<p>APPROVALS</p>		<p>DATE</p>	 <p>Wulfsberg Electronics <i>A Chelton Group Company</i></p>			
DRAWN	L. Evans	08/30/04	<p>TITLE:</p> <p>SERVICE BULLETIN WSB IDU-III-12 (KN-53 GLIDESLOPE INTEGRATION)</p>			
CHECKED	D. Boston	08/30/04				
PRODUCT MANAGER	D. Boston	08/30/04				
ENGINEER			SIZE	CAGE CODE	DWG NO.	REV
ISSUED	V. Wallace	08/30/04	A	1B7G3	150-045019	A
<p>Typed signatures indicate approval. Handwritten signature approval of this document is on file at Wulfsberg Electronics, Prescott, Arizona.</p>			SCALE: NONE		DO NOT SCALE DRAWING

SERVICE BULLETIN

EQUIPMENT: IDU-III

BULLETIN NUMBER: WSB IDU-III-11 Revision A

Figure 1

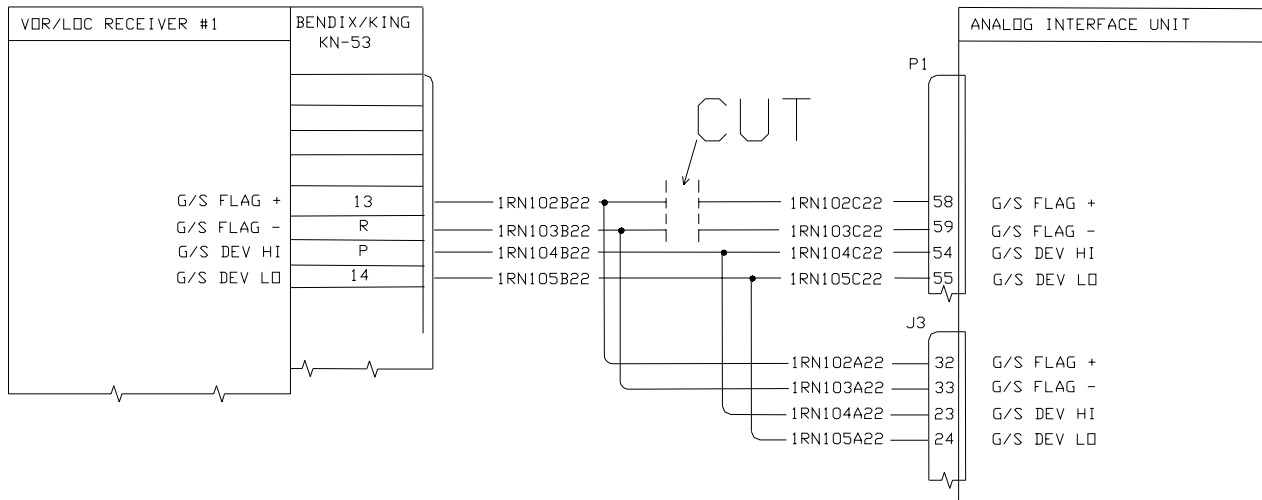
1. Remove all necessary access panels to gain access to the AIU.
2. Cut the Glideslope +Flag and Glideslope –Flag wires approximately 6 inches from the AIU J1 connector (See Figure 1).

Figure 2

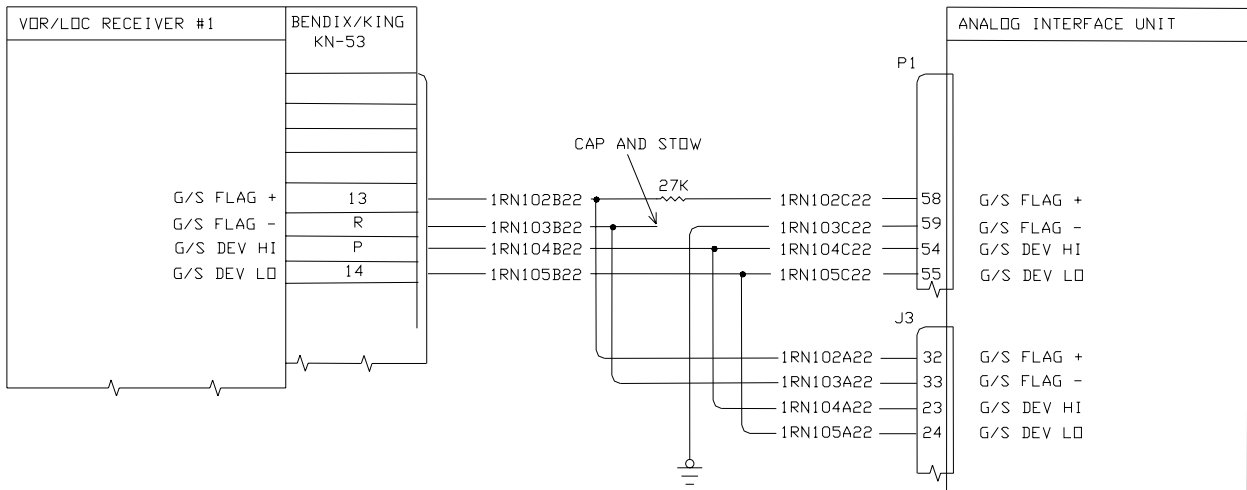
3. Add a 27.0K-ohm resistor (Item 1) to the Glideslope +Flag wire from the KN-53 and to the AIU Glideslope +Flag wire cut in step 1 (See Figure 2).
4. Cap and stow the Glideslope –Flag wire from the KN-53 cut in step 1 (See Figure 2).
5. Connect the Glideslope –Flag wire from the AIU cut in step 1 to a local airframe ground (See Figure 2).
